Response to request for additional information pursuant to section 92 of the Resource Management Act 1991

This letter provides a response to the request for further information pursuant to section 92 of the Resource Management Act 1991 (RMA) received on 3 April 2020 (**Attachment 1**) in regard to the Application (APP-2017201552.00), for resource consents required to authorise the Te Ahu a Turanga: Manawatū Tararua Highway ('the Project').

The following questions relate to Technical Assessment H – Freshwater Ecology, Technical Assessment C – Water Quality, Appendix E Proposed Conditions and the Ecology Management Plan

Figure 1: Relationship between TSS and Turbidity in the Manawatū River at Teachers College Site.

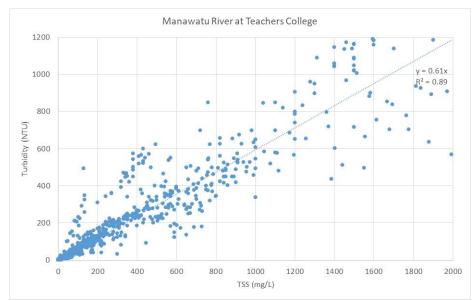
The variables TSS, turbidity and water clarity can often be used as proxies for each other – but within limits. If one wants to convert between turbidity and TSS, then ideally a relationship is determined for any particular catchment. The Technical Assessment C - Water Quality, used a long dataset from the Manawatū River to establish relationships between TSS, turbidity and black disc clarity valid for turbidity values less than 1200 NTU (paragraph 28 of Technical Assessment C). The relationship between TSS and turbidity gets weaker at higher concentrations – possibly because of the mobilisation of different types of sediment with different scattering properties at higher flows (Figure 1).

Figure 2: Relationship between turbidity and black disc clarity in the Manawatū River at Teachers College site, and in 1 hour CART bench tests (Appendix 1.A of Erosion and Sediment Control Plan).

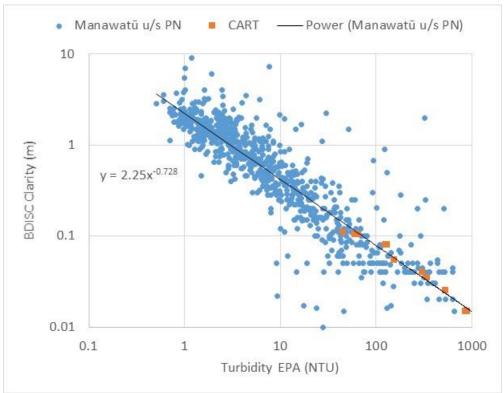
Some caution is needed if using relationships between TSS and turbidity or clarity derived from the Manawatū River to apply as an end-of-pipe standard from erosion and sediment control devices. Figure 2 demonstrates that individual measurements show considerable scatter around the general relationship between turbidity and clarity. Consequently, the uncertainty of estimating a 'true' value will be higher when applying equations to a single spot measurement that might be used for comparison with a water quality standard, as compared to applying it to a mean or median of multiple measurements. The application proposes that turbidity and clarity are measured from sediment control devices and the results used to assess treatment effectiveness and to trigger management responses.

Figure 3: Turbidity in Top Graph - Catchment 2 (Mangamanaia Stream) and Bottom Graph - Catchment 7 (Raukawa Stream)

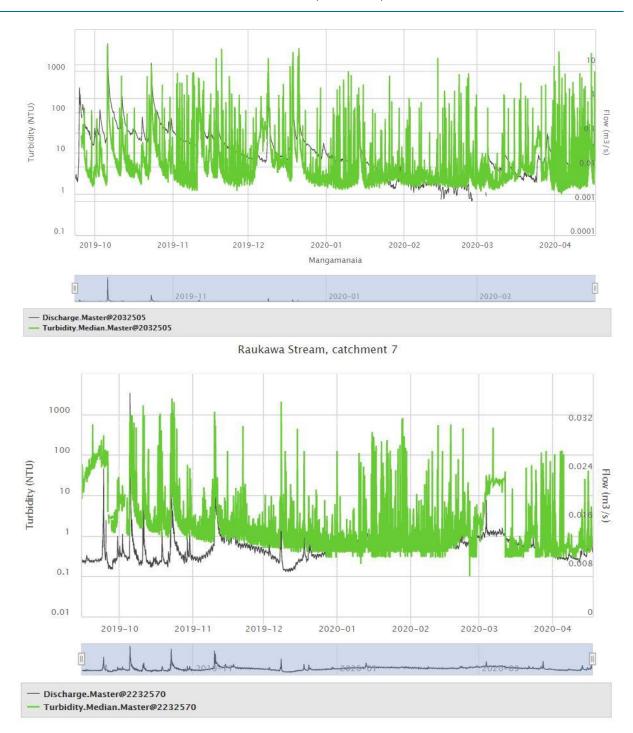
Developing a practical water quality standard for TSS that relates to effects on aquatic life is challenging because of the very high natural variability in TSS and lack of upstream controls. Table C.3 and C.5 of Technical Assessment C shows the variability of clarity, TSS and turbidity results of monitoring in Catchments 2 to 7 and in the Manawatū River. Outputs from continuous monitoring loggers in Catchments 2 and 7 are provided below in Figure 3 to further illustrate this variability. The figures show that turbidity is often high (e.g. >100 NTU) and often spikes in turbidity (green lines) are independent of measured flow or rain events (black lines – labelled discharge).

Figure 4: Wetland W03 discharge points

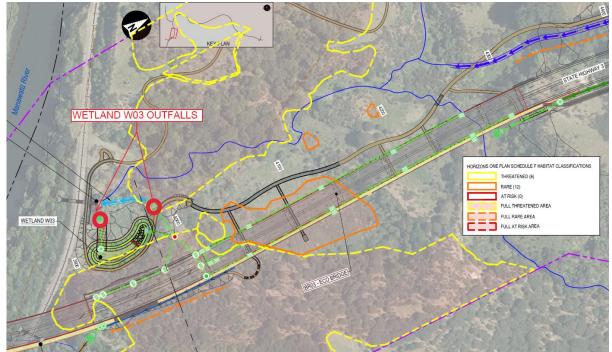
The location of Wetland 03 and its discharge locations in relation to Schedule F 'threatened' habitat is shown in Figure 4 below. A discharge permit is sought pursuant Rule 13-9 of the One Plan and section 15 of the RMA as a non-complying activity for discharges of stormwater (once operational from Wetland 03) to a rare habitat or threatened habitat.

This is the only the stormwater treatment device located within a Schedule F habitat.
